# HCT alignment modifications based on technical analysis

*Southwest Corridor Plan*

**DISCUSSION DRAFT 4/15/15**

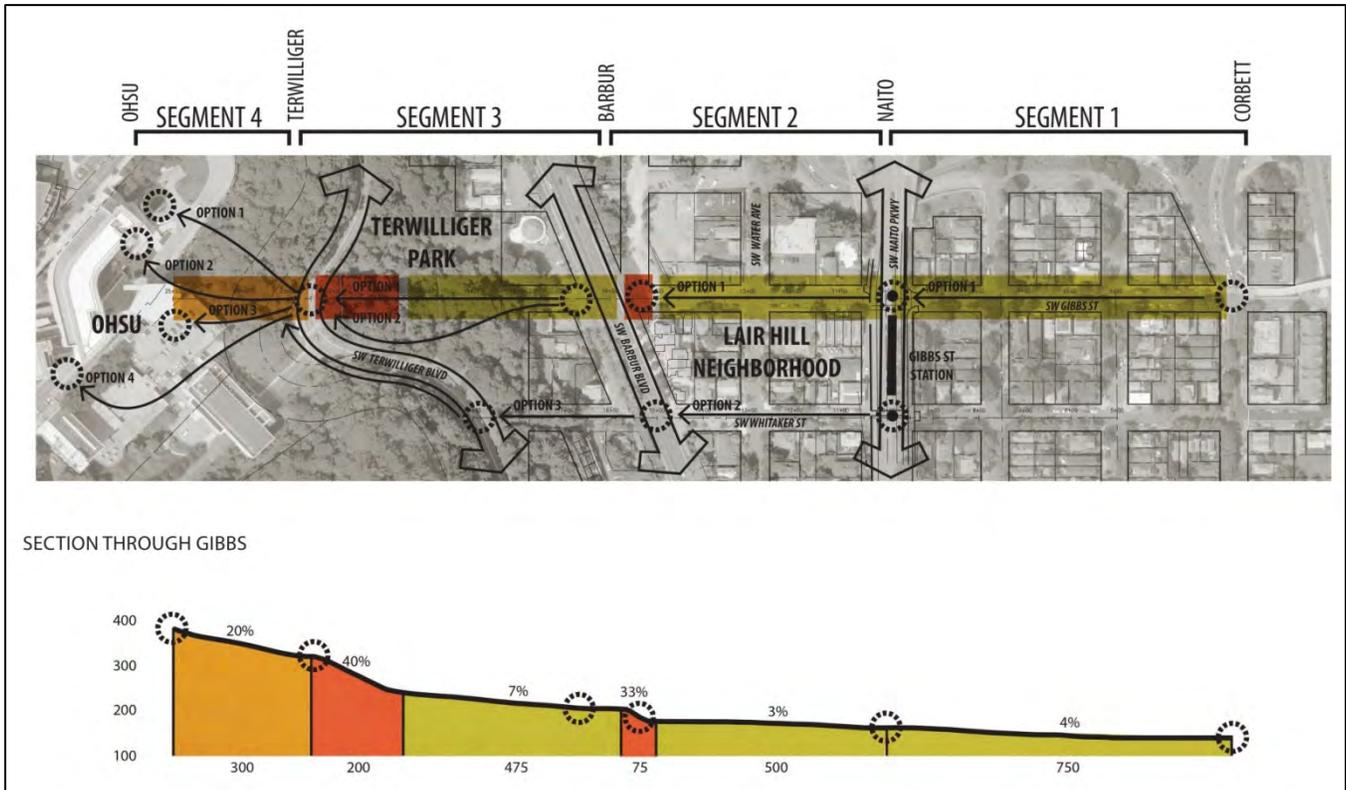
***Proposed modification: remove options parallel to I-405 and keep BRT alignment on 1st Avenue as a contingency option***

Project staff recommend removing the two alignment options that parallel I-405, C and E above, which have engineering challenges that may be very difficult to overcome and could hinder potential future modifications of I-405 ramps. Additionally, the Naito-I-405 alignment has limited options for a station to be located near the PMLR Lincoln station.

BRT on 1<sup>st</sup> north of Lincoln is recommended only as a contingency option for BRT on Naito due to the poor connection to PSU and slow travel times resulting from running in mixed traffic on 1<sup>st</sup> Avenue, Columbia and Jefferson. This alignment will only be evaluated further if running BRT on Lincoln is later found to be unfeasible.

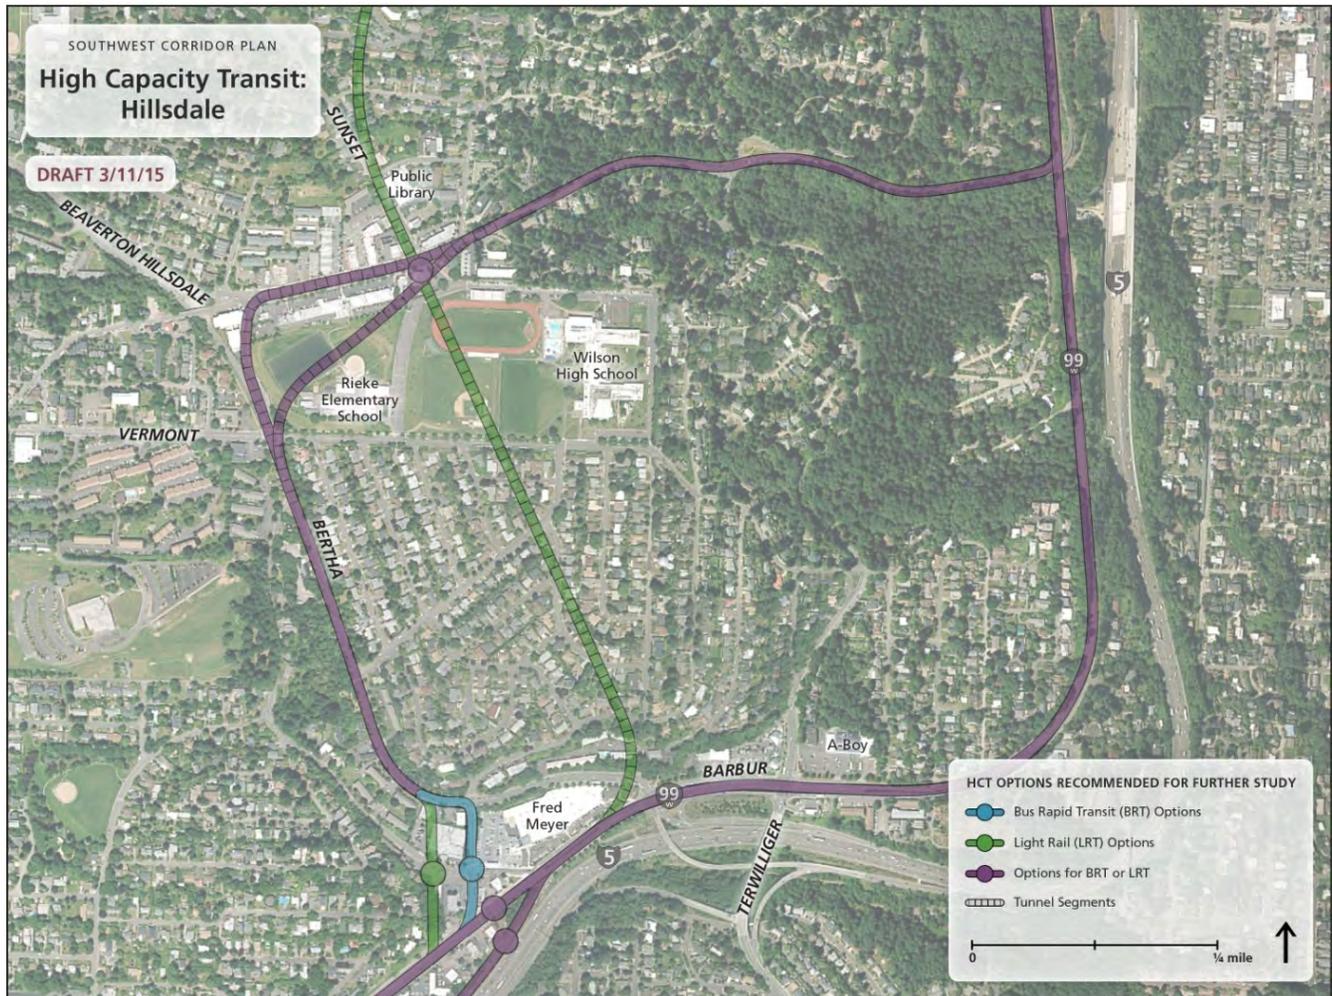
*Proposed modification: replace Marquam Hill tunnel with Marquam Hill-Hillsdale tunnel*

After further analysis, project staff recommend replacing the Marquam Hill tunnel with the Marquam Hill-Hillsdale tunnel due to the high fixed cost of bored tunnels, greater travel time savings, the opportunity to provide direct access to the Hillsdale town center, and community preference for the longer tunnel over the shorter tunnel.

The one-mile Marquam Hill tunnel would have a relatively high ratio of fixed to linear costs. The fixed costs, which include retaining walls at the portals, roadway modifications and a tunnel boring machine, would account for approximately 49 percent of the total cost of the tunnel (based on year 2014 dollars without financing or escalation costs). The remaining half of the cost would be from linear costs, including track, overhead wires, excavation and structural materials for the tunnel itself. In contrast, the total cost of the 2.8-mile Marquam Hill-Hillsdale tunnel would be composed of 24 percent fixed costs and 76 percent linear costs.

While the Marquam Hill tunnel would save approximately 24 seconds of travel time compared to light rail on Barbur Boulevard, the Marquam Hill-Hillsdale tunnel would save over one minute. These reductions in travel time would benefit riders beyond only those accessing Marquam Hill or Hillsdale. Model results show that the two tunnels would have a similar number of boardings at the Marquam Hill station, but the longer tunnel has a higher line ridership and more new system transit trips due to its greater travel time savings and direct access to Hillsdale.

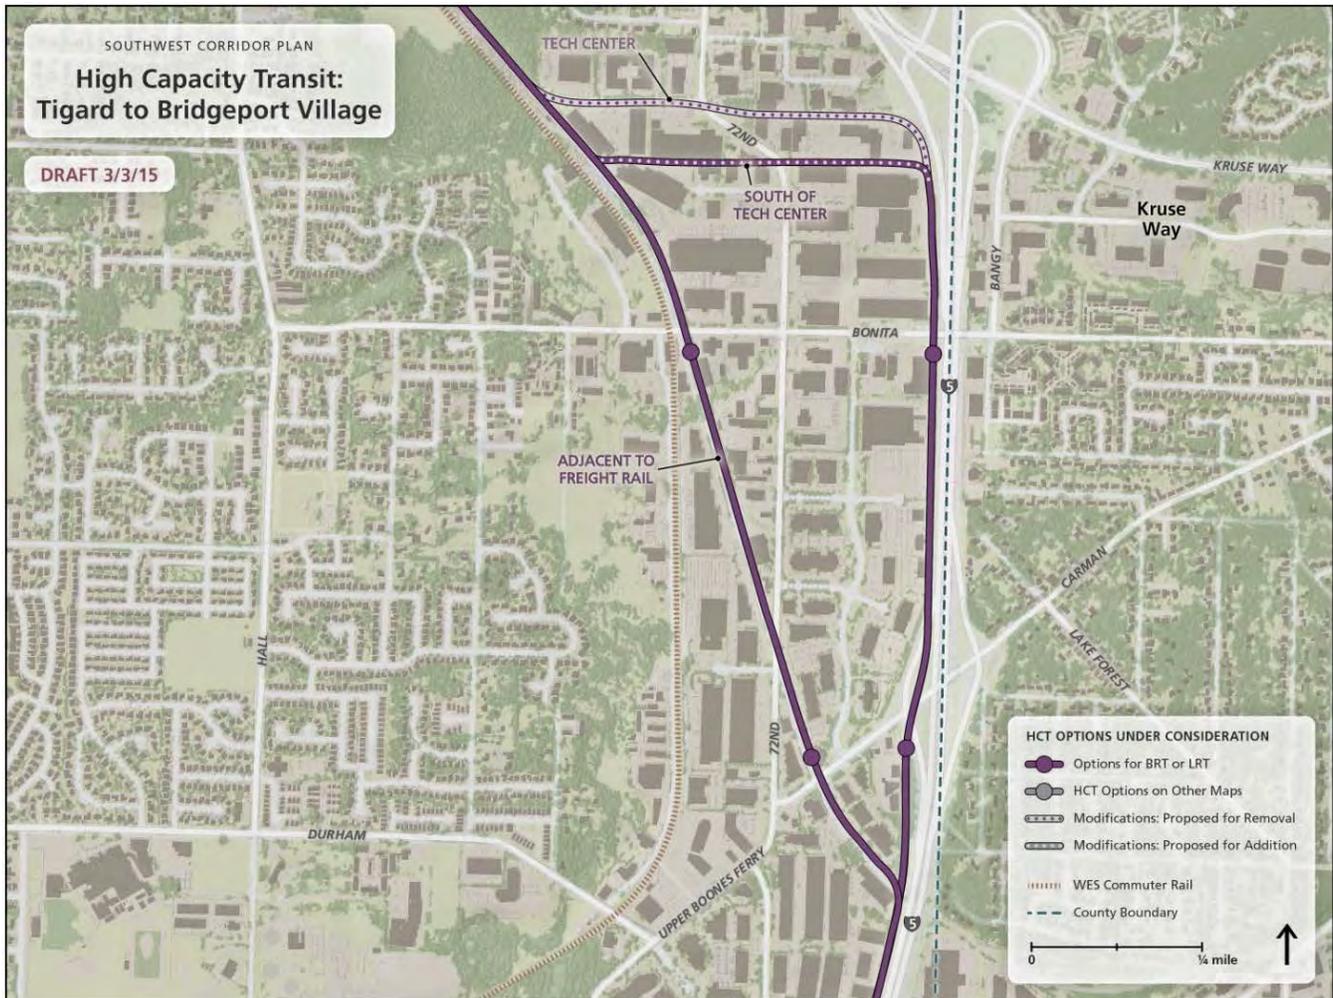
***Proposed modification: replace 68th/69th Avenue couplet with 68th/70th Avenue couplet***

In June 2014, the Steering Committee recommended to continue studying a 68<sup>th</sup>/69<sup>th</sup> Avenue couplet option in the Tigard Triangle and to remove the two-way 68<sup>th</sup> Avenue and 68<sup>th</sup>/70<sup>th</sup> couplet alignments from consideration. Following that decision, significant concerns were raised about how that decision impacted local land use planning that was underway in the Tigard Triangle. After carrying out further analysis during the project's 2014 focused refinement period, project staff recommend that the 68<sup>th</sup>/70<sup>th</sup> couplet alignment replace the 68<sup>th</sup>/69<sup>th</sup> couplet for further study.

The preliminary drawings of the 68<sup>th</sup>/69<sup>th</sup> couplet envisioned 68<sup>th</sup> running northbound and 69<sup>th</sup> running southbound, with HCT along the left side of each street, one lane of auto traffic in the middle, and a bike lane on the right. With this street configuration, access to properties between 68<sup>th</sup> and 69<sup>th</sup> would be limited to driveways connecting to the east-west cross-streets, which would have signalized intersections to allow vehicles to cross the HCT guideway. By shifting the southbound HCT alignment from 69<sup>th</sup> to 70<sup>th</sup>, properties located in between 68<sup>th</sup> and 69<sup>th</sup> would be able to maintain driveway access points along 69<sup>th</sup> as well as the cross-streets. This is an important consideration when viewed through the lens of the ongoing work of the Tigard Triangle Strategic Plan. This planning document identifies 69<sup>th</sup> Avenue as a pedestrian focused street, with wide sidewalks, bike lanes and on-street parking and a focus on ground floor retail uses. The plan specifically calls for

69<sup>th</sup> to be free of any form of HCT, allowing for a focus on slower traffic and a more enjoyable pedestrian and cycling experience. The removal of 69<sup>th</sup> Avenue as a consideration for HCT supports the land uses envisioned in the Tigard Triangle Strategic Plan along the street to become more viable.

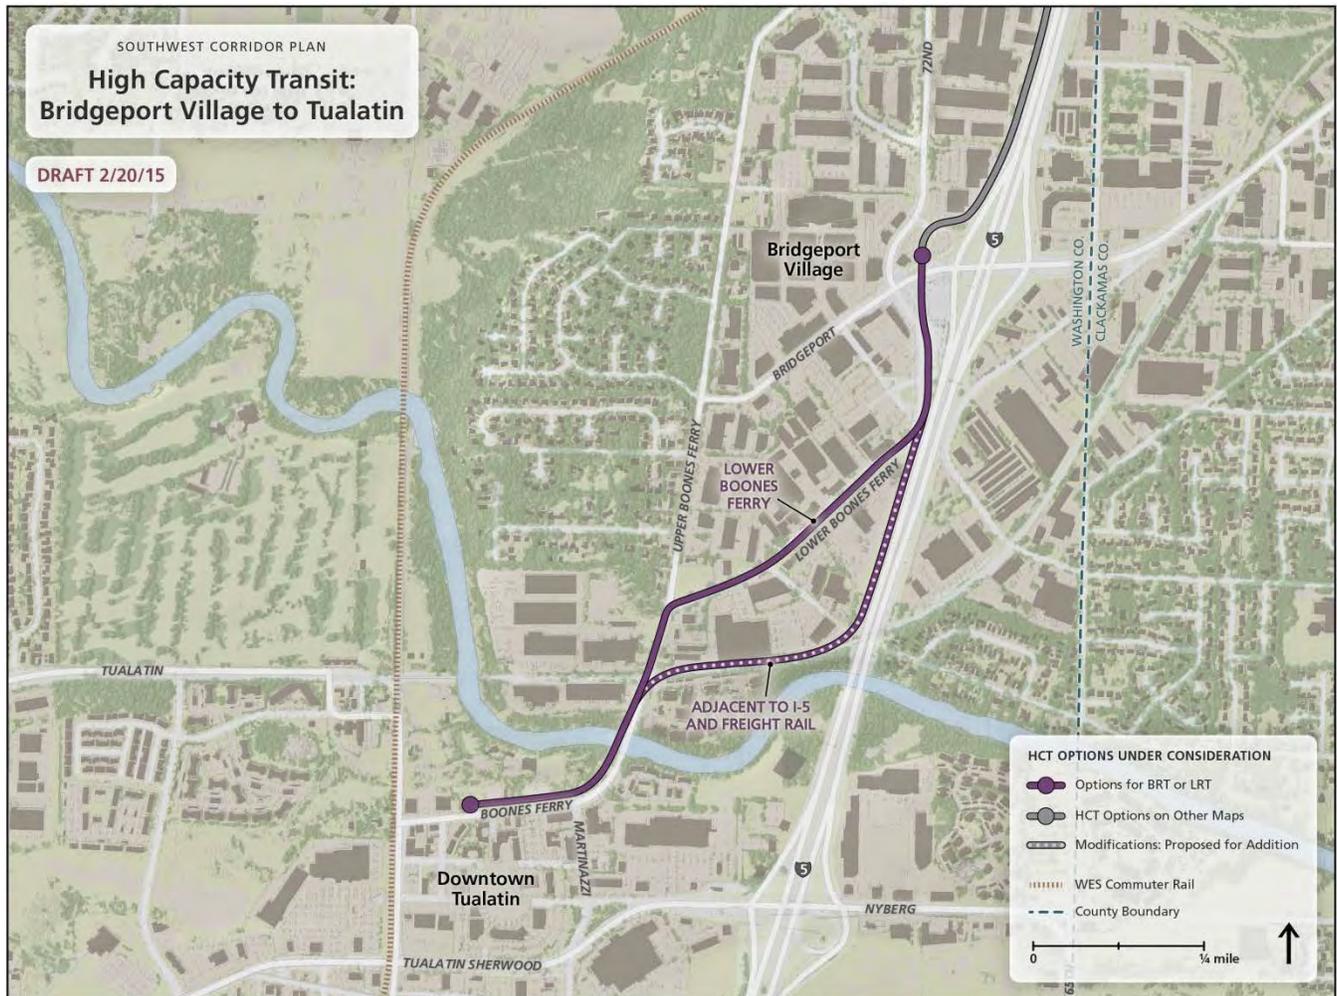
### *Proposed modification: shift Tech Center Drive alignment south to cut between industrial buildings*

After further review, project staff recommend modifying the Tech Center option running from Tigard to Tualatin. The preliminary drawings showed HCT running along Tech Center Drive between the WES tracks and 72<sup>nd</sup> Avenue, then continuing directly west of Tech Center toward I-5. However, access impacts to adjacent properties and the steep slopes along this path added to the engineering complexity and cost of the alignment. Since these initial drawings, project staff have found that running HCT in between the industrial buildings just south of Tech Center, where the slopes are flatter and impacts to access of the adjacent parcels can be minimized, is a more promising alignment.
